**GEORGETOWN MIDDLE-HIGH SCHOOL RENOVATIONS
Georgetown, MA**

ADDENDUM NO.2

February 13, 2015

RP2-19
 Ref. Dwg. P1-1-4A

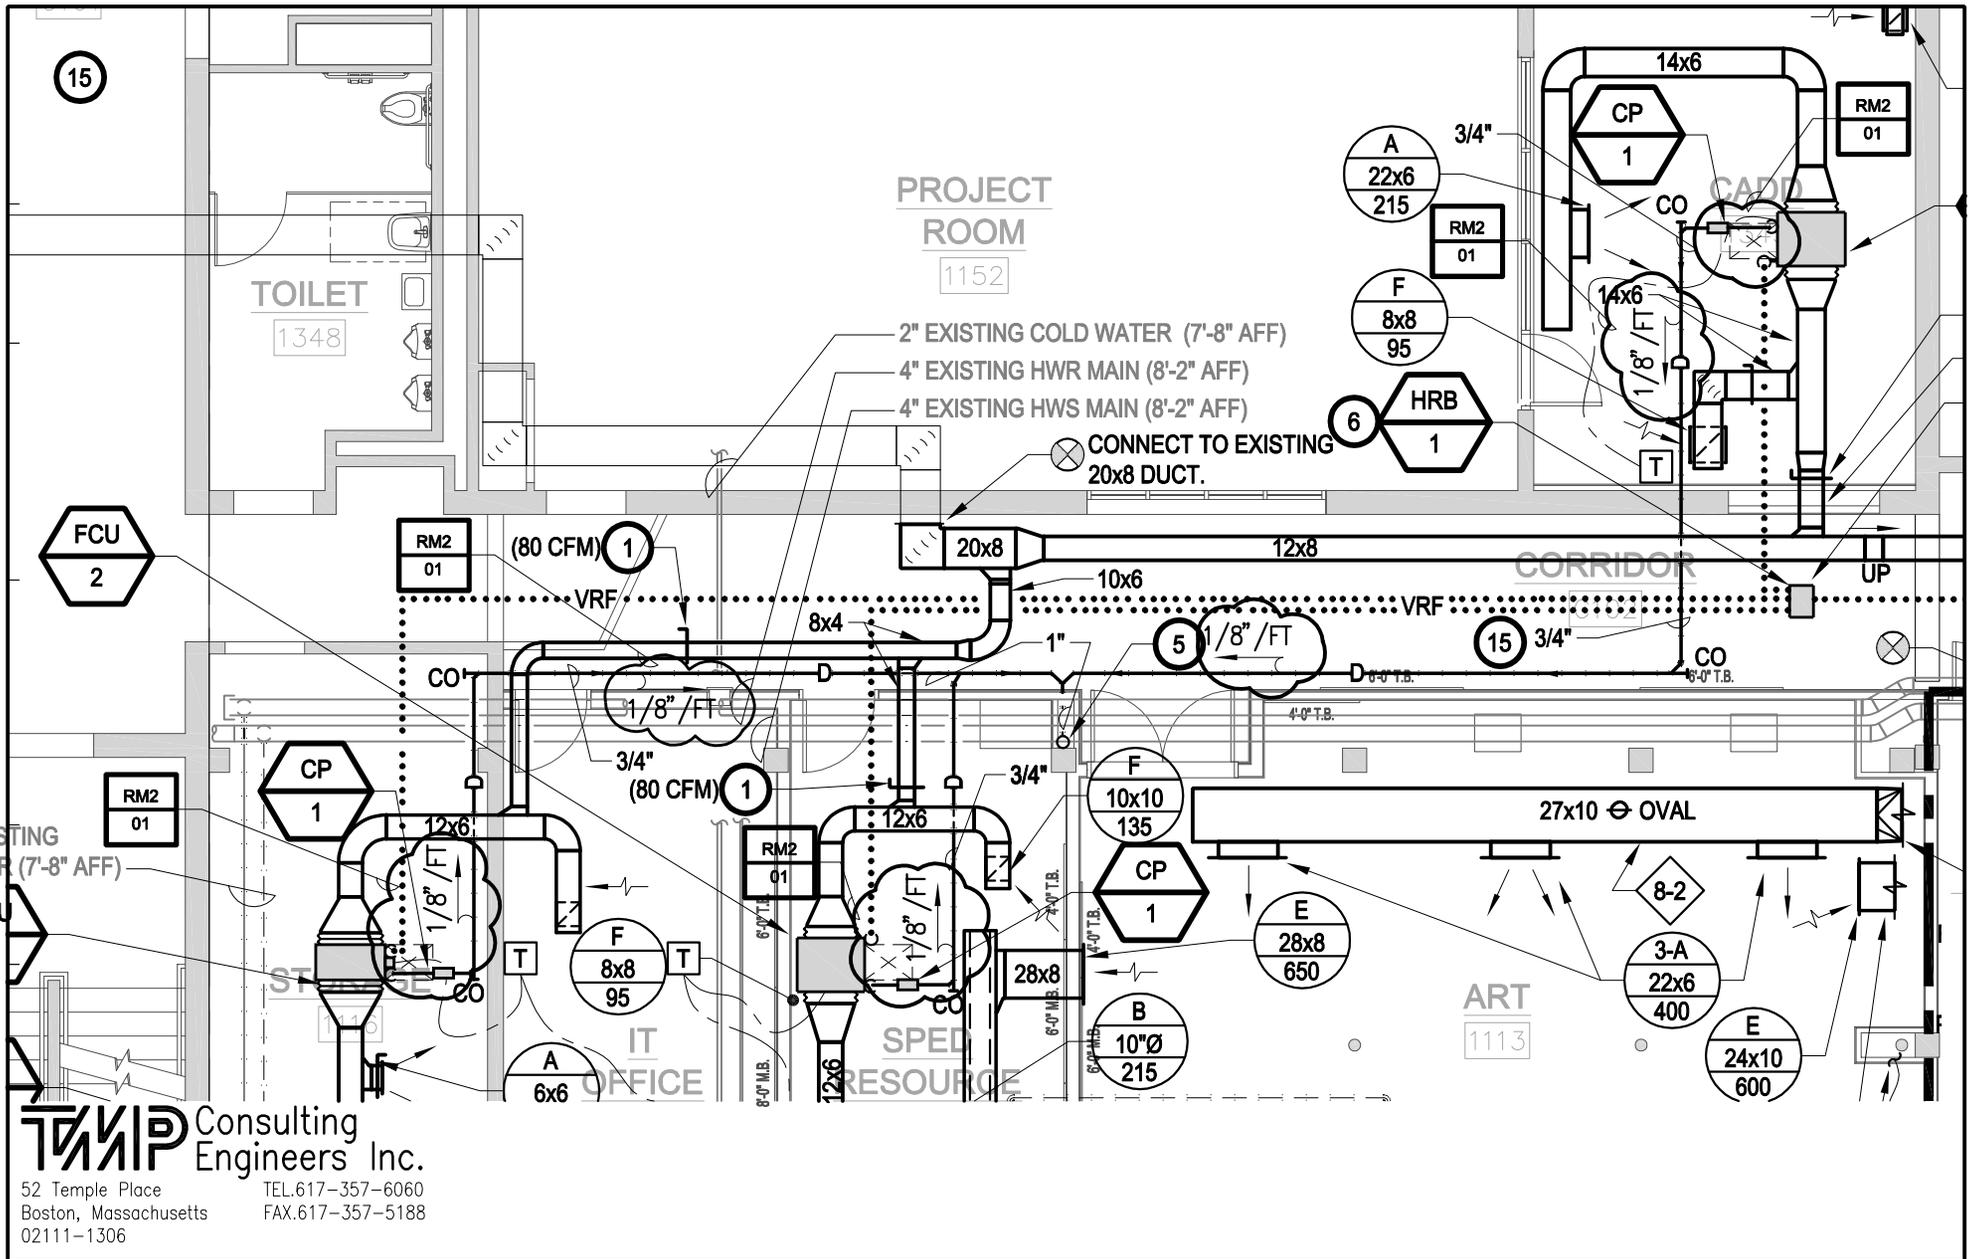
- ADD 2-49 P1-1-3A PLUMBING ROOF PLAN AREA A**
ADD Roof Drain. Refer to attached sketch RP2-18.
- ADD 2-50 P1-1-3A PLUMBING ROOF PLAN AREA A**
ADD Gas Train Vents. Refer to attached sketch RP2-19.

D.R.A.
 RM2-01
 Ref. Dwg. M1-1-1A

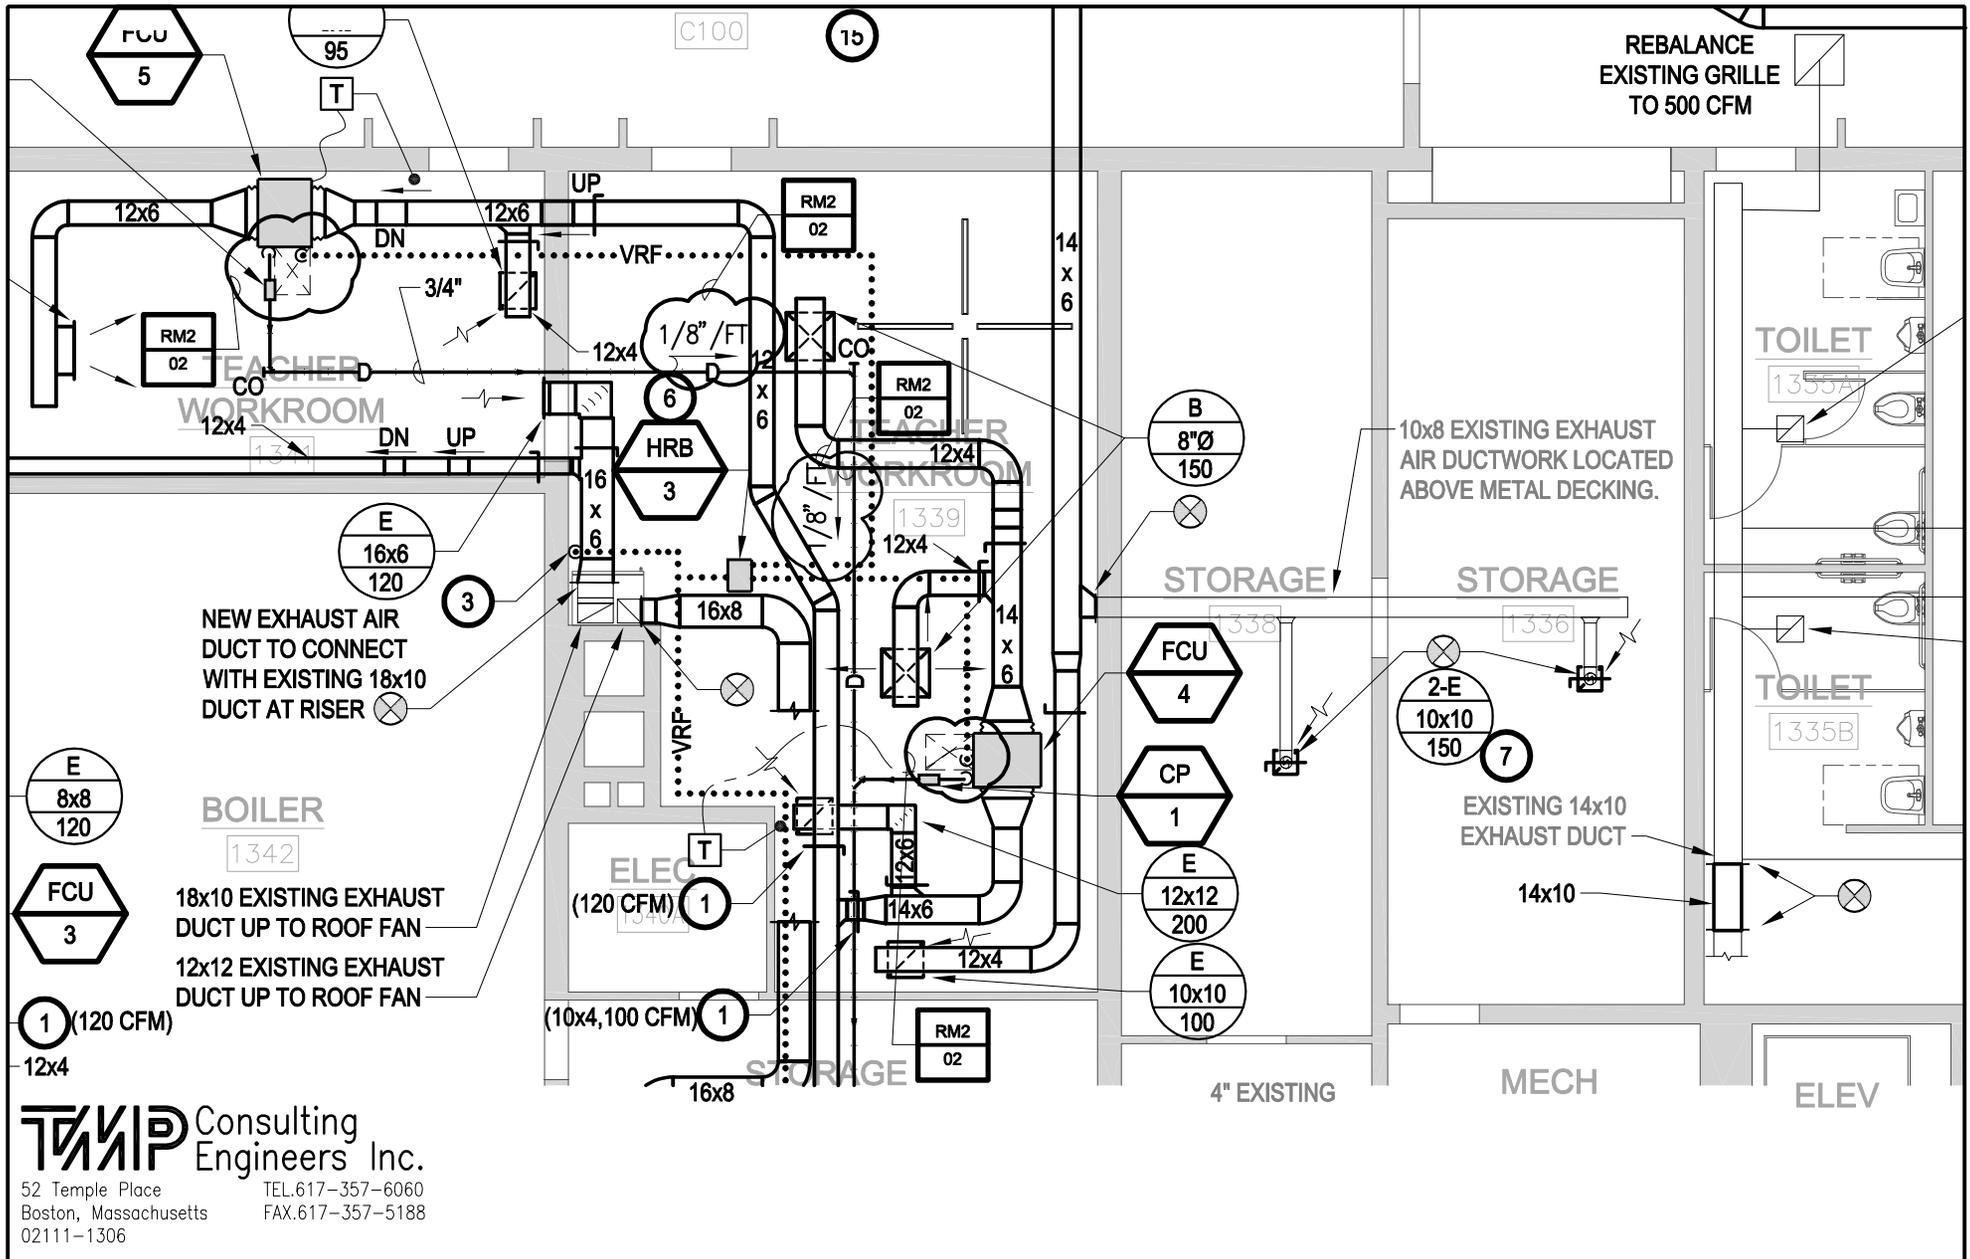
ADD drain pitch annotation and equipment access annotation. Refer to attached sketch RM2-01.

D.R.A.
 RM2-02
 Ref. Dwg. M1-1-1A

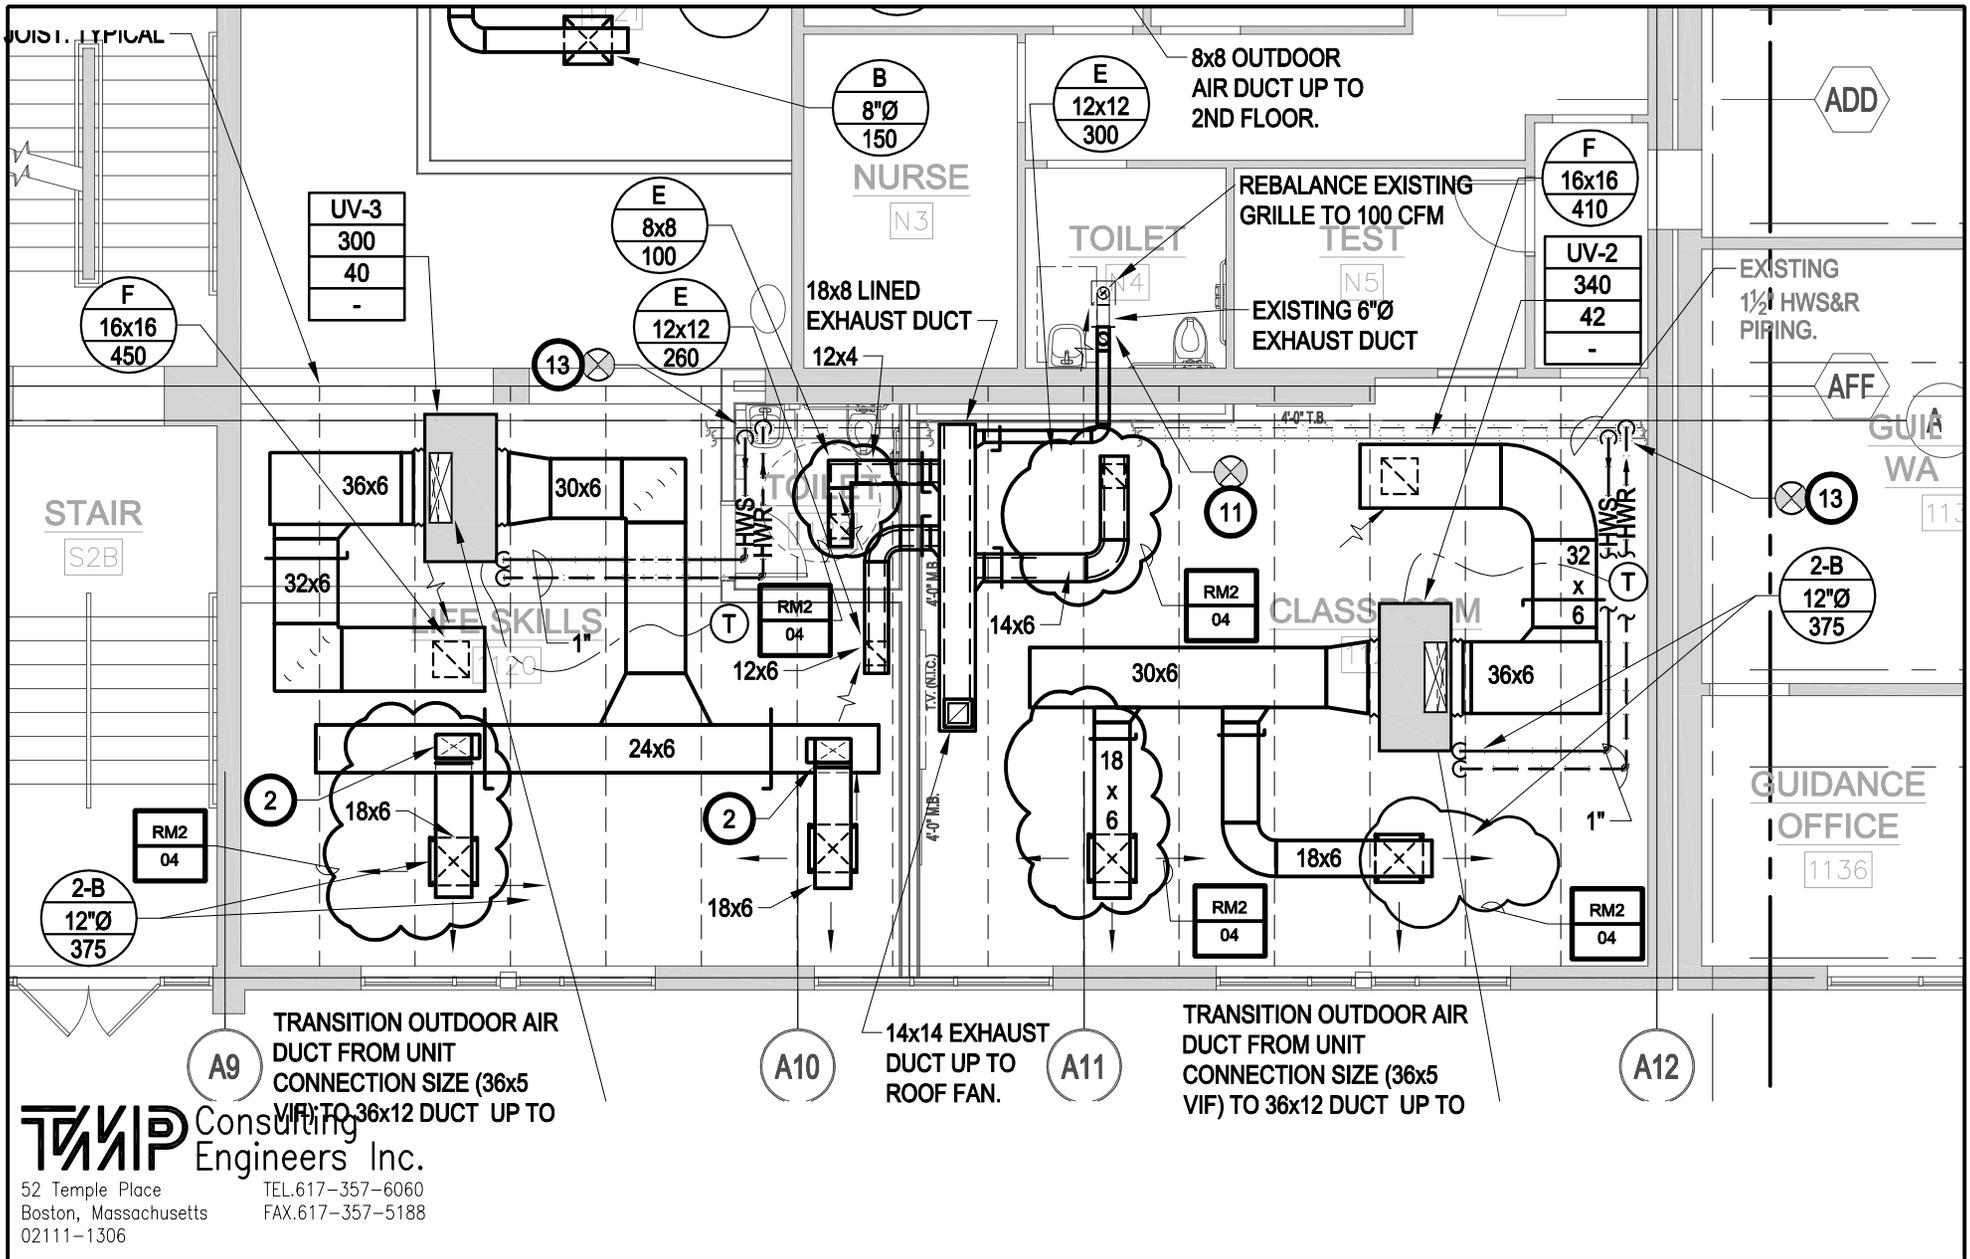
ADD 2-52 M1-1-1A – HVAC FIRST FLOOR PLAN AREA A
ADD drain pitch annotation and equipment access annotation. Refer to attached sketch RM2-02.

D·R·A
 RM2-04
 Ref. Dwg. M1-1-1A

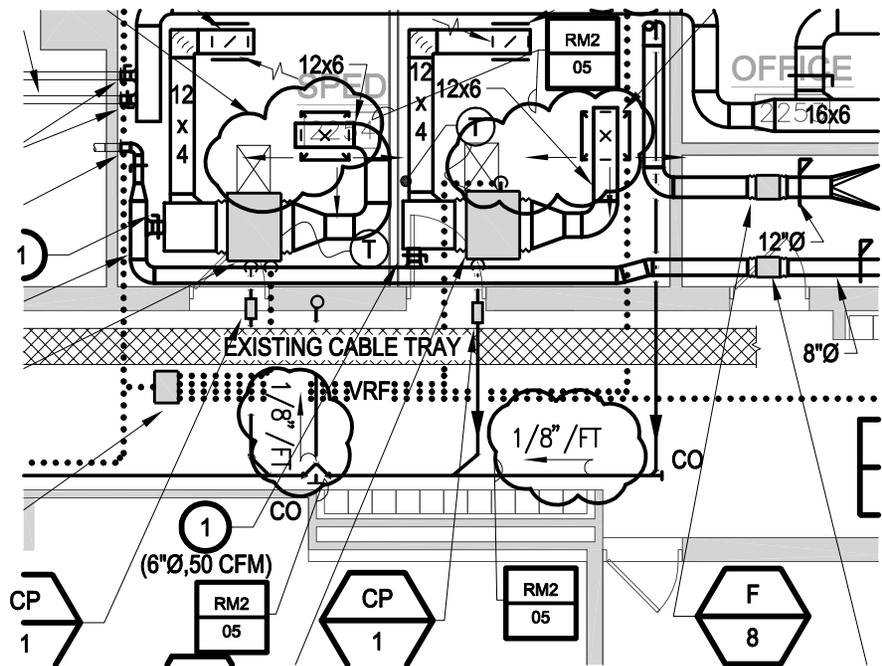
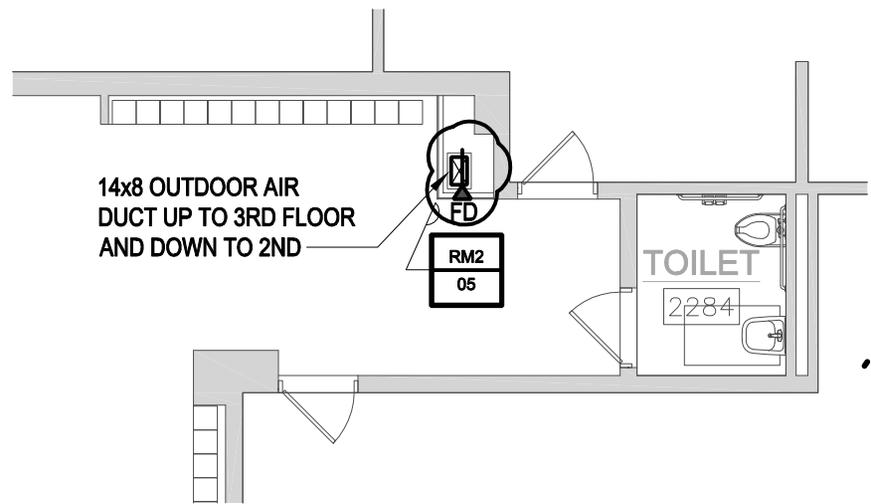
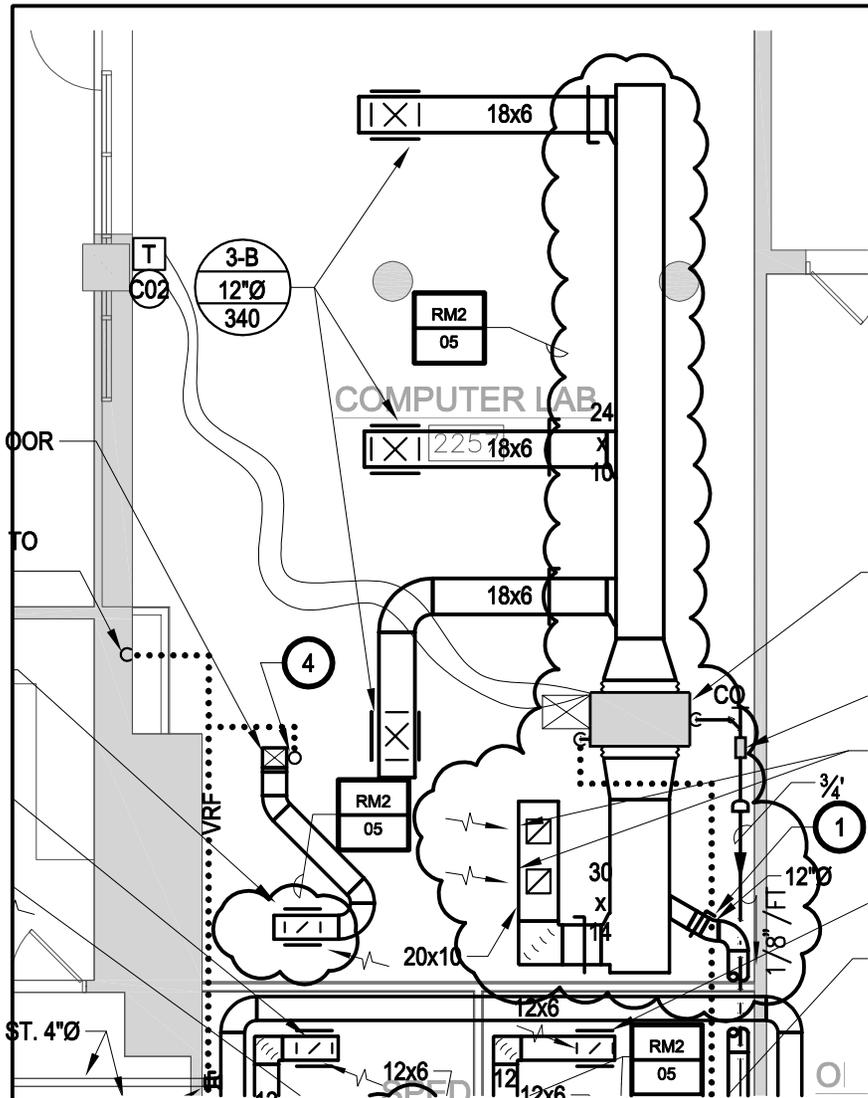
ADD 2-54 M1-1-1A – HVAC FIRST FLOOR PLAN AREA A
ADD drain pitch annotation and equipment access annotation. Refer to attached sketch RM2-04.
